**ONTARIO ENERGY BOARD
IN THE MATTER OF AN APPLICATION BY
HALTON HILLS HYDRO INC. (“HHHI”)
2021 COST OF SERVICE APPLICATION
INTERROGATORY RESPONSES FROM HALTON HILLS HYDRO INC.**

ENERGY PROBE INTERROGATORIES AND RESPONSES

Table EP IRR – 2 – 2016-2025 CAPEX by Category

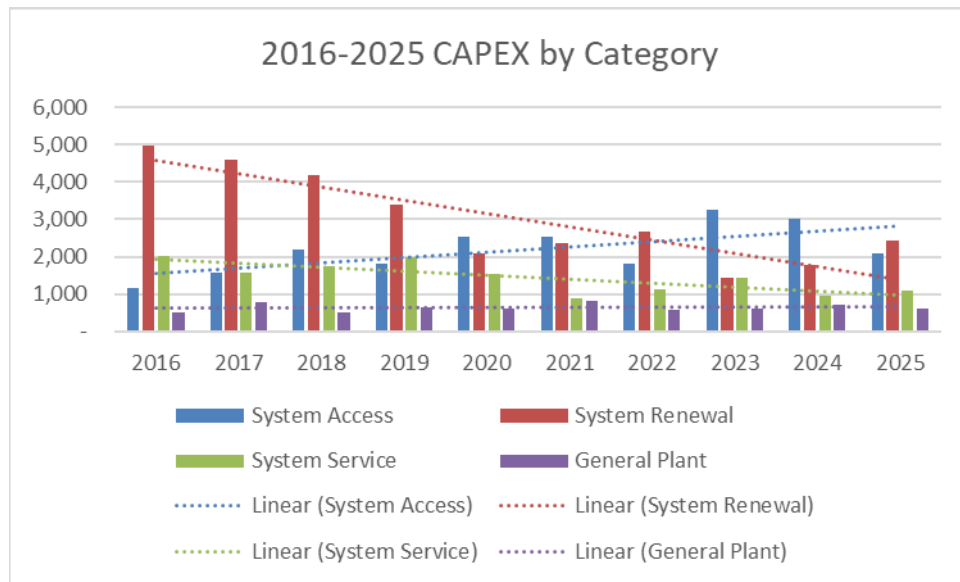
- a) Please file a chart of the 2016-2025 Capex data for each asset category, showing planned and actuals by year
- b) Please provide trend lines.
- c) Please discuss reasons for the major variation in System Access capital.
- d) Please discuss the reasons for the major variations in General Plant capital
- e) How will the DSS ensure the 2021-25 Capex will be spent as per the DSP? Please discuss.

- b) Please see HHHI’s response 1 – EP IRR – 3 part a.
- c) System Access projects are modifications, including asset relocation, to the distribution system that a distributor is obligated to perform to provide a customer (including a generator customer) or group of customers with access to electricity services via the distribution system. Annual expenditures are largely related to customer driven work and can vary significantly from year-to-year.

There was a 68% reduction in capital expenditures related to System Access projects from 2016 to 2017. The primary driver for this reduction in expenditures is largely due to reduced spending on Technical Service Layouts and microFIT/ FIT projects.

There was a 494% increase in capital expenditures related to System Access in 2018 as compared to 2017. The increase in capital spending is largely related to Technical Service Layout and Meter Exchanges.

There was a 15% reduction in capital expenditures related to System Access in 2019 as compared to 2018. The reduction in capital spending can be attributed to reduced spending for Technical Service Layout.

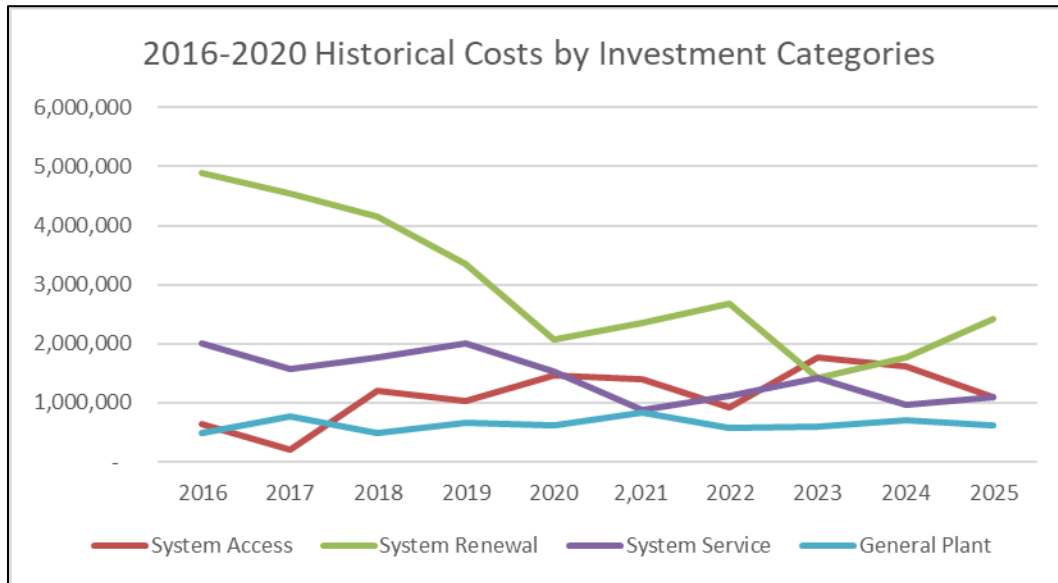
- a) Please discuss why System Renewal expenditures have materially reduced in 2018-2020?
- b) Please project Figure 53 data to 2021-2025 using Table 58 data.
- c) Please reconcile the DSP to the planned asset replacement categories in response to interrogatory 1-EP-10 and to Table 61 by providing a table showing the number of SR assets planned to be replaced from 2021-2025.
- d) Why are the planned Poletrans Replacement and Substation Equipment investments “volatile/lumpy”?

- a) System Renewal investments involve replacing and/or refurbishing system assets to extend the original service life of the assets and thereby maintain the ability of the distributor’s distribution system to provide customers with electricity services.

There was a reduction of 7% in capital expenditures from 2016 to 2017 relating to System Renewal projects.

- The small reduction in capital expenditures relates to a reduction to pole replacements and deferring substation projects at Cross MS and Silvercreek MS in 2017. However, the reduction is offset by an increased level of spending in 2017 relating to underground rebuilds in the Lakeview, Acton and John Street, Georgetown areas as well as capital expenditures made at Mountainview MS and Willow MS as compared to 2016.

There was a reduction of 16% in capital expenditures from 2018 to 2017 relating to System Renewal projects.
